Access Compliance Report

Public Rights-of-Way

Intersection ID: 12110	Main Street: S_MINT_ST	Cross Street: W_4TH_ST	Location: S
ADA ID: E8D52622DBAA	Ramp Type: Perp	Initial Pass/Fail: Fail	Overall Compliance: No
		Severity Score: 12.5

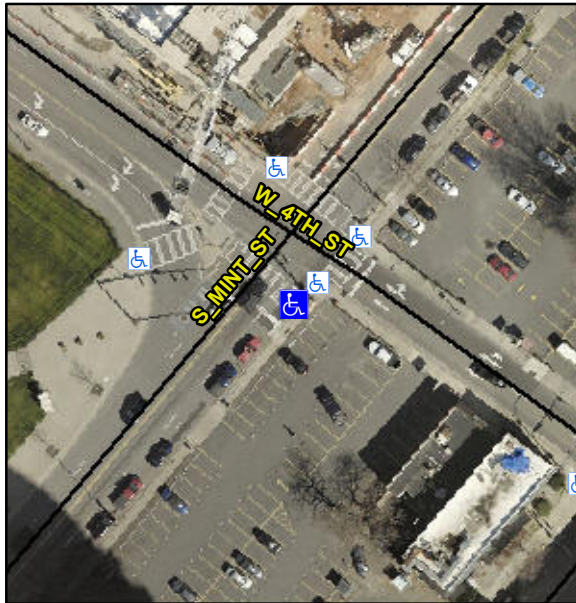
Not Found, R304.5.3

Compliance	Description	Data	Compliance	Description	Data
N/A	Ramp Length (in)	85.0	Yes	Ramp Slope (%)	7.7
Yes	Ramp Width (in)	49.0	No	Ramp XSlope (%)	6.1
N/A	Flare Type LT	N/A	N/A	Flare Type RT	N/A
N/A	Flare Slope LT (%)	N/A	N/A	Flare Slope RT (%)	N/A
N/A	Flare Traversable LT?	N/A	N/A	Flare Traversable RT?	N/A
N/A	Landing Length (in)	N/A	N/A	DWS Provided?	N/A
N/A	Landing Width (in)	N/A	N/A	DWS Contrast?	N/A
N/A	Landing Slope (%)	N/A	N/A	DWS Length (in)	N/A
N/A	Landing X Slope (%)	N/A	N/A	DWS Full Width?	N/A
N/A	Landing Curb? (Y/N)	N/A	N/A	DWS Offset (in)	N/A
N/A	Shared Landing?	N/A			
N/A	Gutter Ponding?	N/A	N/A	Gutter Slope (%)	N/A
N/A	Gutter Lip Ht (in)	N/A	N/A	Gutter X Slope (%)	N/A
N/A	Painted X Walk1?	Yes	N/A	Painted X Walk2?	N/A
	X Walk 1 Direction	To NW		X Walk 2 Direction	N/A
N/A	X Walk 1 Width (in)	136.0	N/A	X Walk 2 Width (in)	N/A
	X Walk 1 Slope (%)	7.2		X Walk 2 Slope (%)	N/A
	X Walk 1 X Slope (%)	4.8		X Walk 2 X Slope (%)	N/A

Remove & Replace Entire Ramp.
